# Revised Work Plan to Evaluate Effective Groundwater Capture at Tronox Extraction Systems, Tronox LLC, Henderson, Nevada

ENSR Corporation  
August 2007  
Document No.: 4020-023-160

**Subject: Revised Work Plan to Evaluate Effective Groundwater Capture at  
Tronox LLC, Henderson, Nevada**

### **Response to NDEP (June 26) Comments to the May 30, 2007 Draft Work Plan**

**PROPOSED WELLS AT THE INTERCEPTOR WELL FIELD**  
 Capture Zone Workplan  
 Tronox Facility  
 Henderson, Nevada

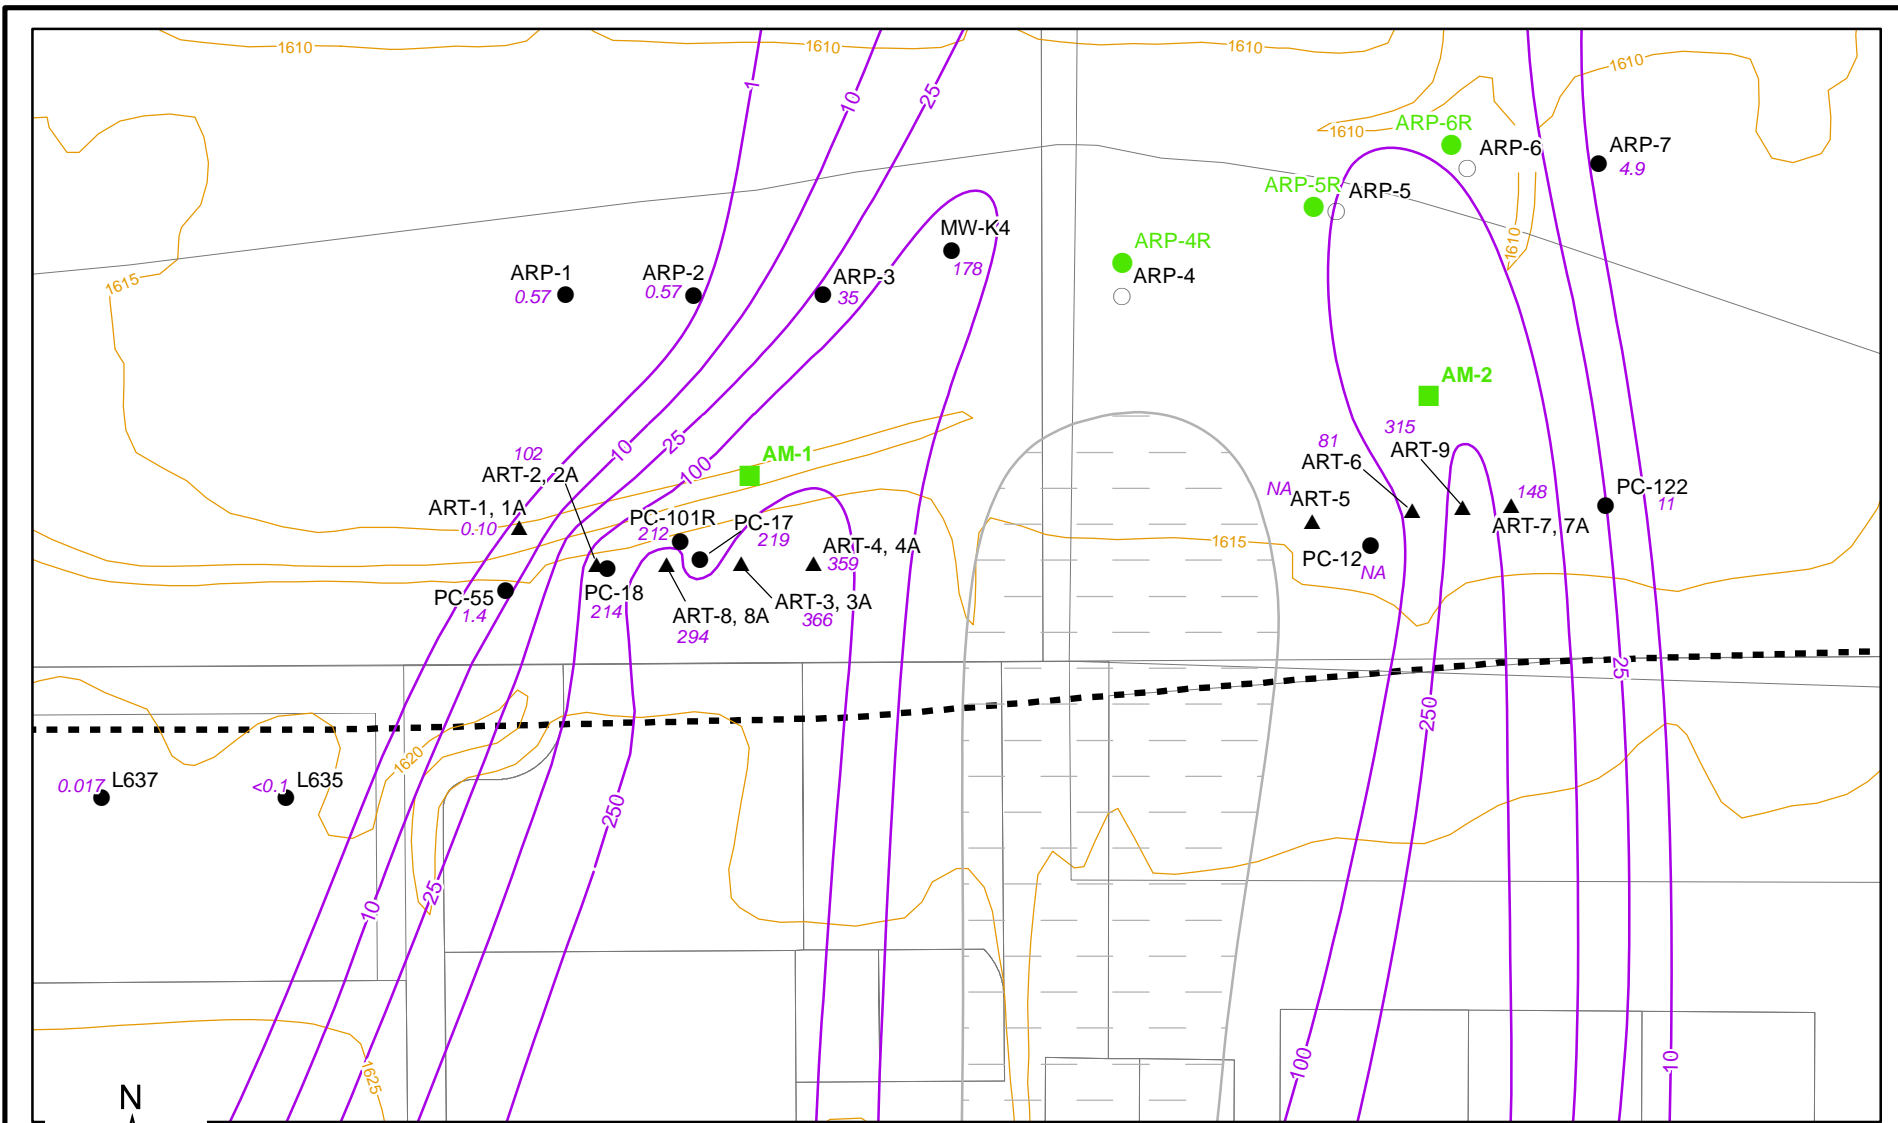
- a. The NDEP requests that this statement be supported with the installation of at least two monitoring wells at both locations as illustrated in Figure 1 (see following comment) to measure gradient. Flow may then be calculated using these newly installed monitoring wells and M69 (west side) and M74 (east side).

- b. Please note that the NDEP is including Figure 1 as example of possible well locations for comment clarity. TRX may propose different well locations.

- c. TRX should include a map illustrating the proposed locations of the monitoring wells. This comment applies to other portions of the work plan as well.

a. /b. /c. TRX will install groundwater monitor wells at each end of the barrier wall at locations shown in Figure 2 of the Revised Work Plan to Evaluate Effective Capture at Tronox Extraction Systems (August 2007). TRX will provide a map showing the proposed well locations along with any other proposed monitor wells,, piezometers, or additional recovery wells in the revised work plan.
